CALCULATED	MJB
	CHECKED
PSB	
PAVEMENT SUBSUMMARY	
MED - 3 - 09 . 04	
18 80

MED - 3 - 09 - 04

ROUNDABOUT SPLITTER ISLAND DETAILS

CURB STEP DETAIL

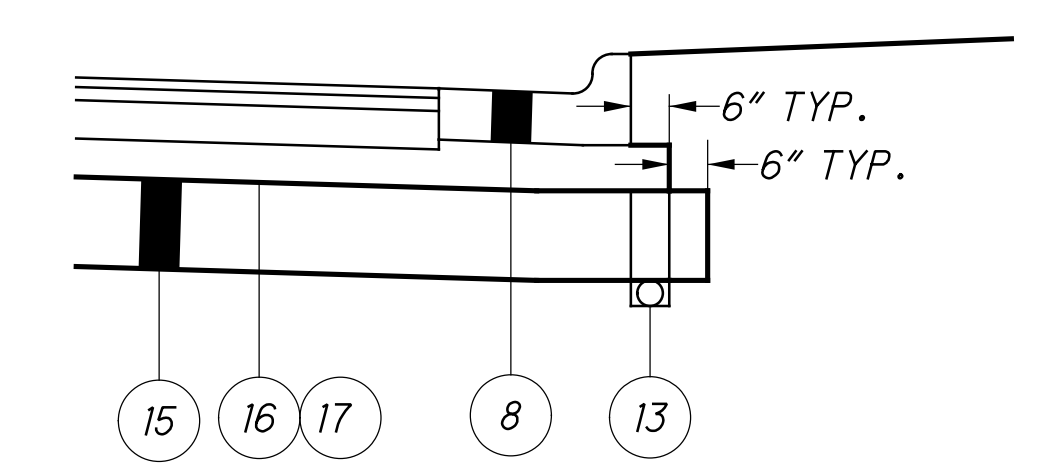
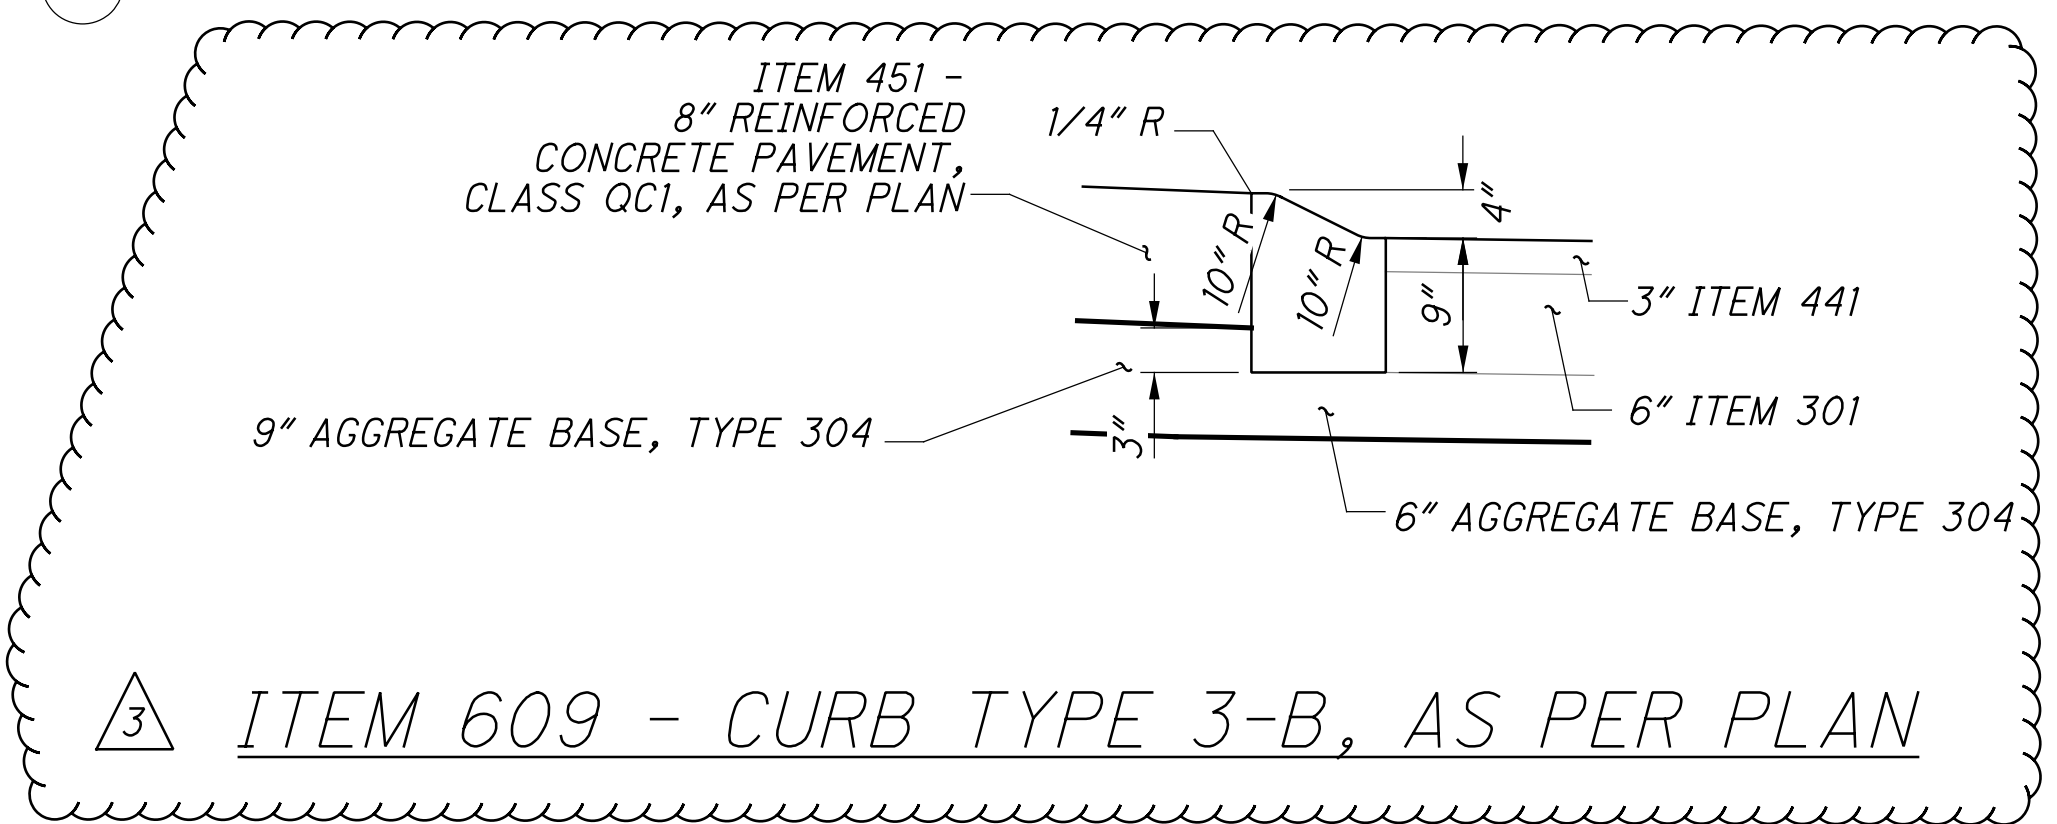
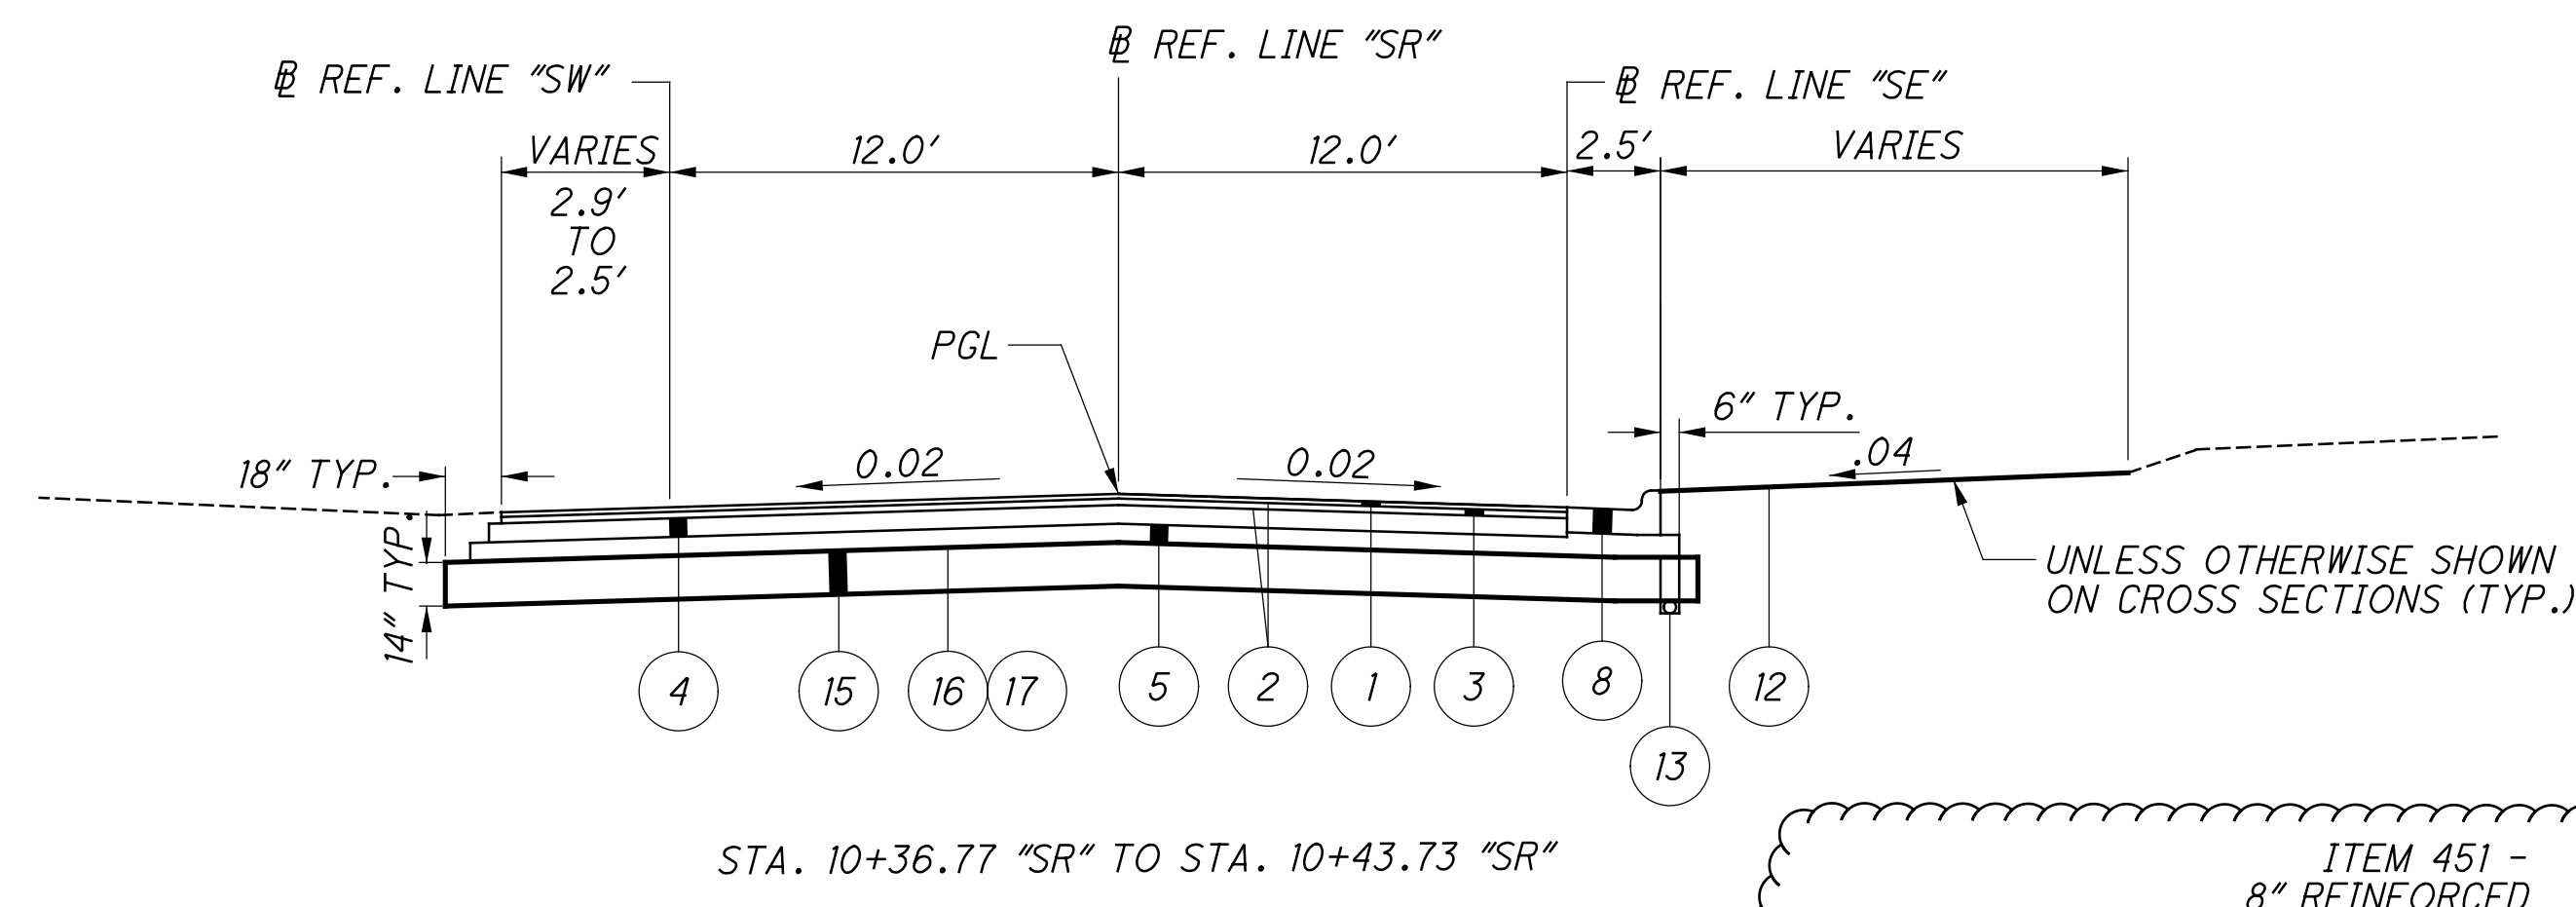
3 REVISED TO "AS PER PLAN"

ROUNDABOUT
INTERSECTION DETAIL

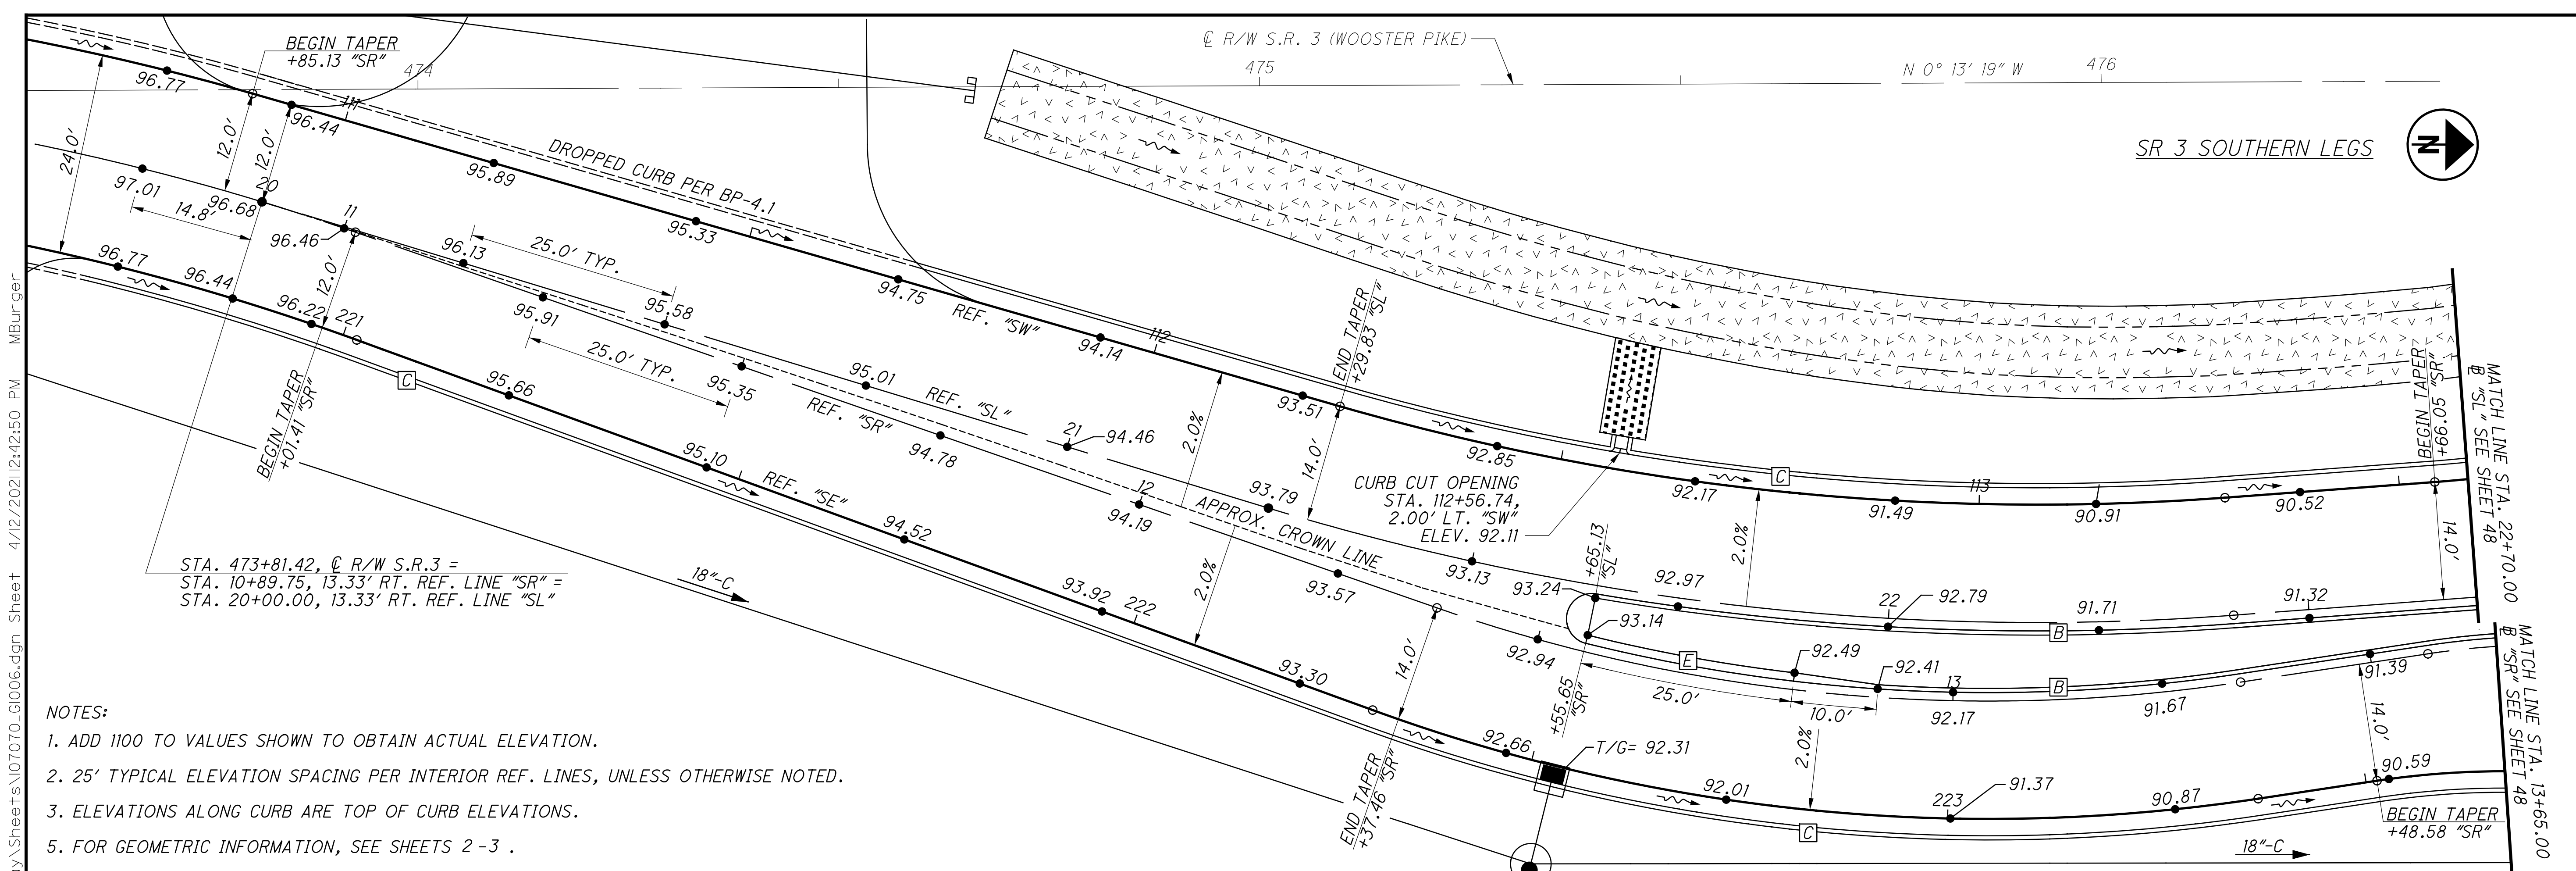
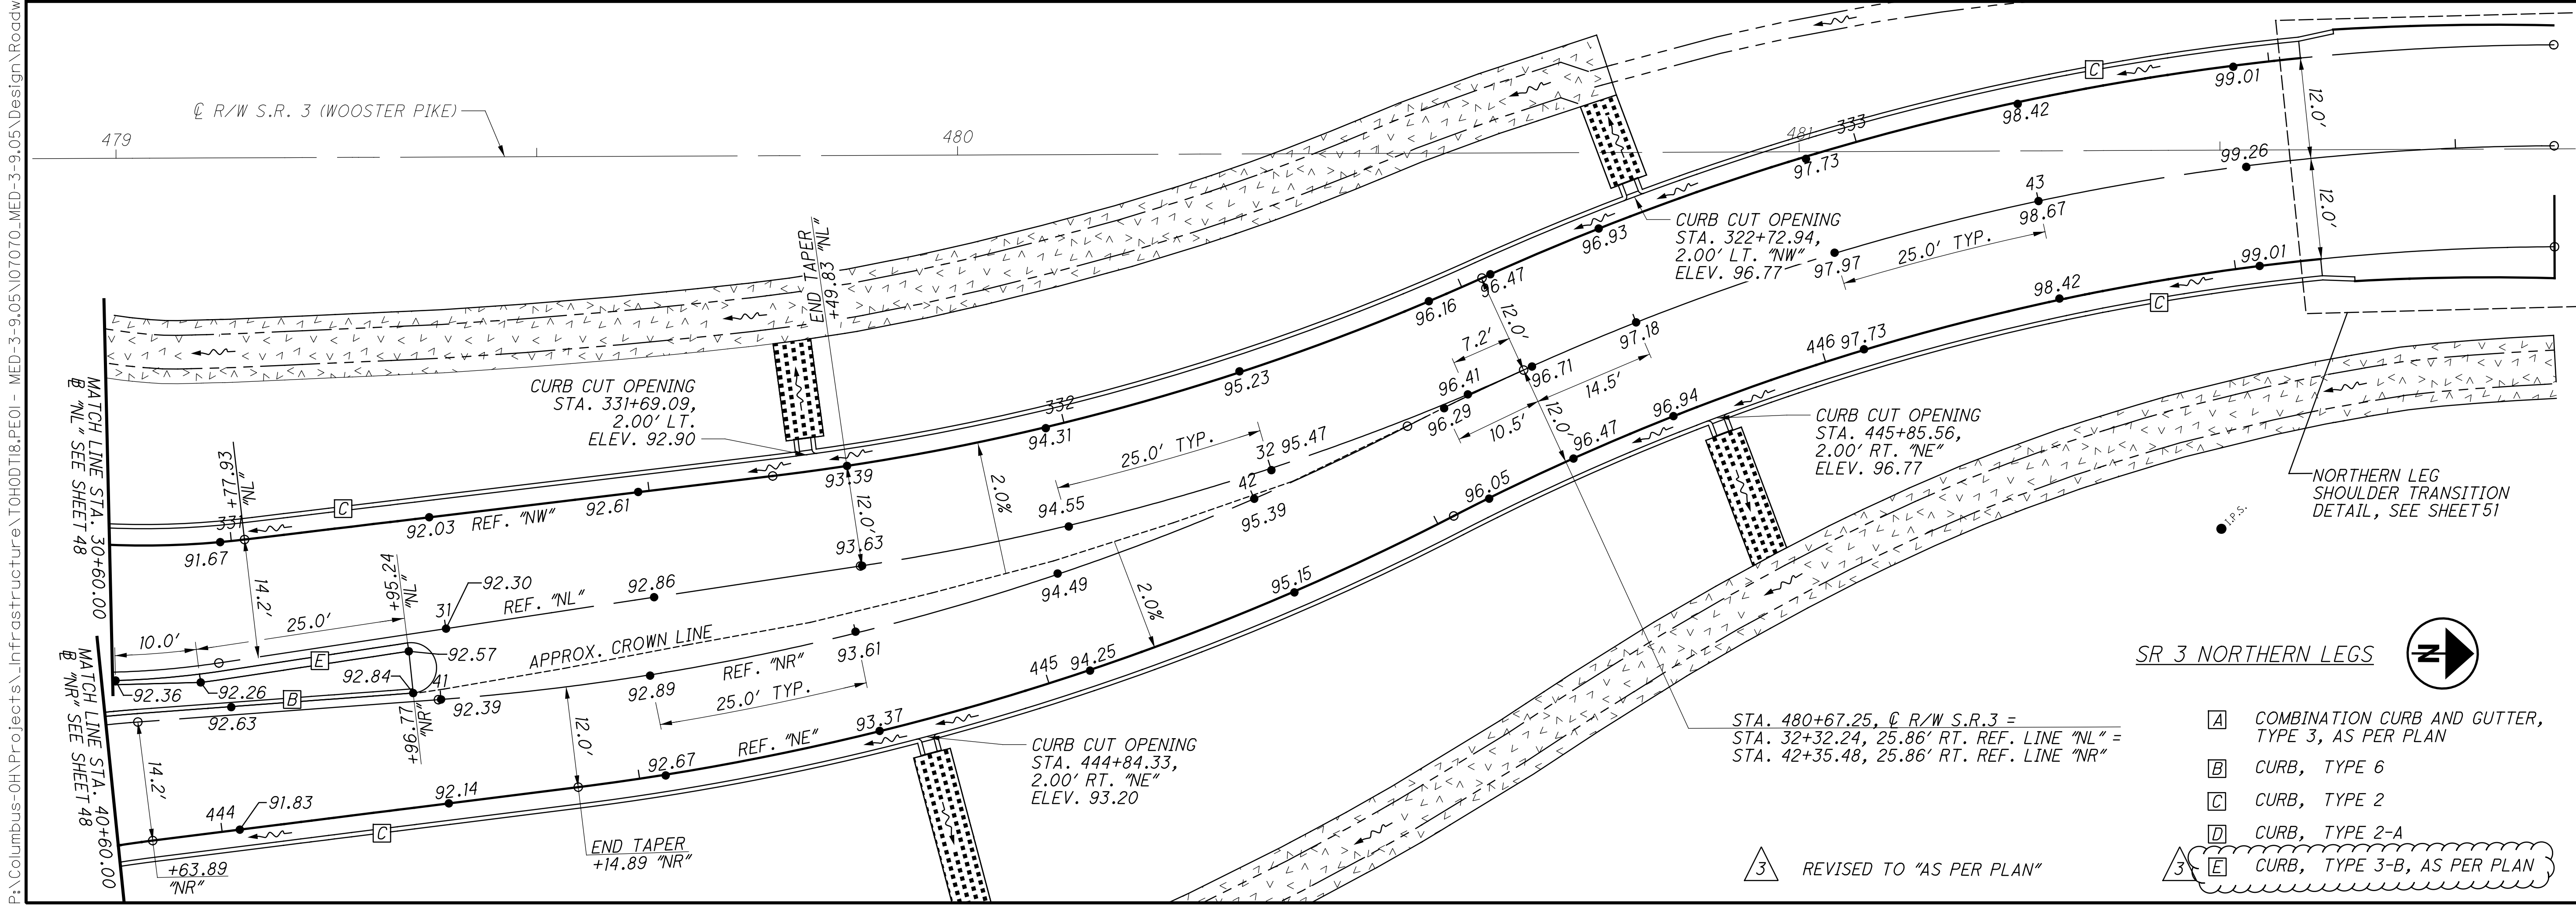
3 REVISED TO "AS PER PLAN"

3 REVISED TO "AS PER PLAN"
